Re: App 2025 #14 - Zoning Amendment Petition for ECCE Overlay District

In addition, please find enclosed suggested revised amendment text for the proposed ECCE Overlay, redlined against the previously submitted version, for your consideration as modifications. The changes are in the nature of a few clean-up edits and clarifications for the community based on the presentations made by us (all of which further define the permitted building envelope for 320 Charles – please see the enclosed plans for the depiction of that envelope). There is no expansion of rights under the proposed overlay, as originally written, with these proposed changes.

320 CHARLES

Figure 1

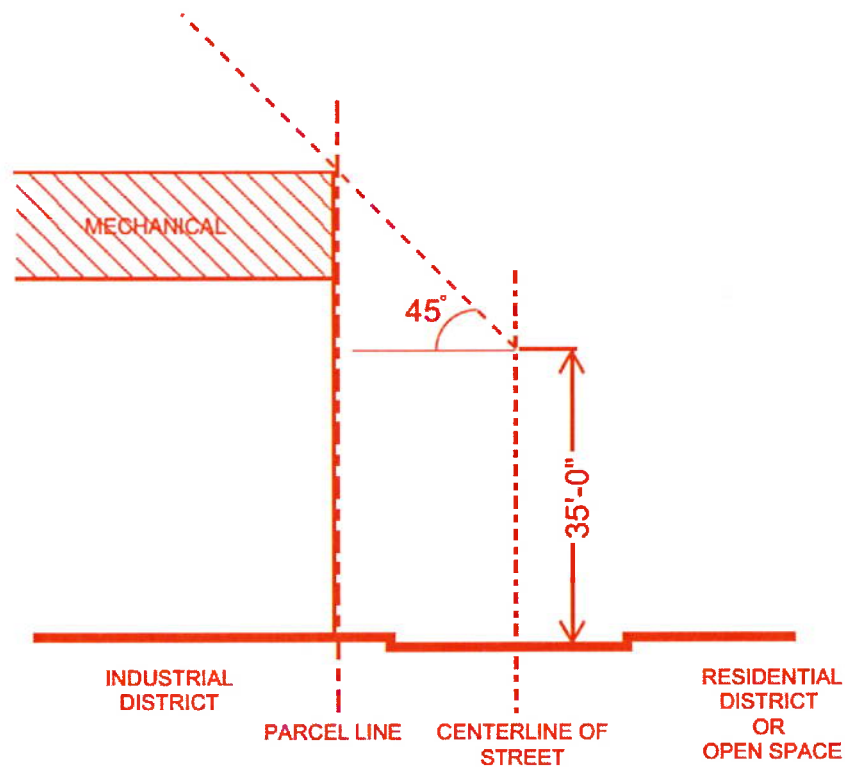
- b. eliminated the revised bulk plane concept (as it is addressed by the aforementioned height changes in a manner that is clearer/easier for laypersons to follow), including deletion of the replacement bulk plane diagram;

- ~~(1) (a) Where the project lot abuts a residential zone (including one located across the street), (a) the building elements enumerated in Section 5.23(a) and (g) as exceptions to height must be below one or more forty-five (45) degree bulk control planes. Each bulk control plane shall begin, in the vertical dimension, at the maximum height limit permitted in the non-residential zoning district. In the horizontal dimension, the plane shall begin at the residential/non-residential zoning district line (or, if the residential zoning district is located across the street from the non-residential zoning district, the center of the street). Thereafter the bulk control plane shall rise from its beginning over the non-residential zoning district. (See illustrative Figure 1 attached).~~
